TSG-RAN Meeting #14
Kyoto, Japan, 11 - 14 December 2001

RP-010771

Title: **Agreed CRs (Rel-4) to TS 25.322**

Source: **TSG-RAN WG2**

Figure 11.4: RLC reset procedure

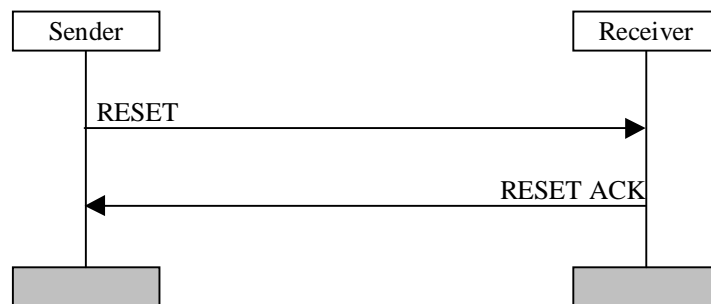
Reason for change: ⌘	If transmission of RESET ACK PDU is delayed due to lower layer scheduling, HFN will be out of synchronization after reset procedure.
Summary of change: ⌘	When the Receiver receives an old RESET PDU (RSN value is same as the previous RESET PDU), the Receiver does not reset itself (its state variables etc.) and responds with a RESET ACK PDU with the same RSN and HFNI value as the previous responded RESET ACK PDU. **The CR has isolated impact:** The RLC reset procedure is clarified. No other functionalities are affected. The CR would not affect implementations behaving like indicated in the CR, would affect implementations supporting the corrected functionality otherwise.
Consequences if not approved: ⌘	Incomplete functionality, potential failure in the RLC reset procedure.

Clauses affected: ⌘	11.4.3, 11.4.5.3

- only submit a RESET ACK PDU to the lower layer with the contents set exactly as in the last transmitted RESET ACK PDU (i.e., in this case the RLC entity is not reset);
